RP-20-98 ERRATA

• *Section 13.0 Lighting Equipment for Garages*

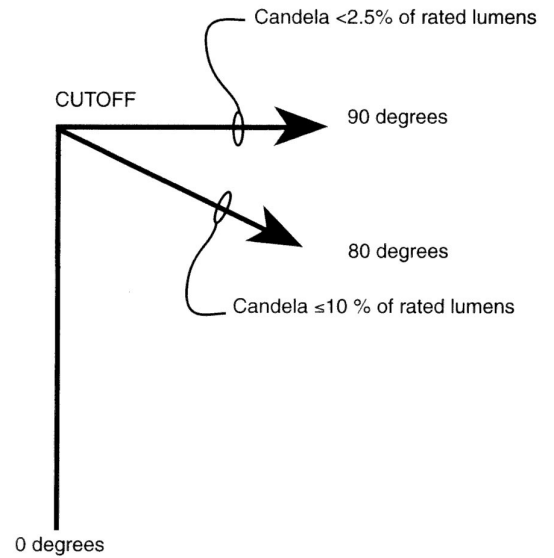
On page 13 there is a section about selecting luminaires for above-ground garages that briefly defines/explains *Cutoff* Luminaires, *Full Cutoff* Luminaires, and *Non-Cutoff* Luminaires (aka *Noncutoff* Luminaires). However, only partial and incomplete definitions of these terms are presented. To bring RP-20-98 into agreement with RP-8-00, *American National Standard Practice of Roadway Lighting*, the following definitions should append and replace the various references to *luminaire cutoff* found in **Section 13.2** and **Section 13.3** of RP-20-98:

Full Cutoff: A luminaire light distribution where zero candela intensity occurs at or above an angle of 90° above nadir. Additionally the candela per 1000 lamp lumens does not numerically exceed 100 (10 percent) at or above a vertical angle of 80° above nadir. This applies to all lateral angles around the luminaire.
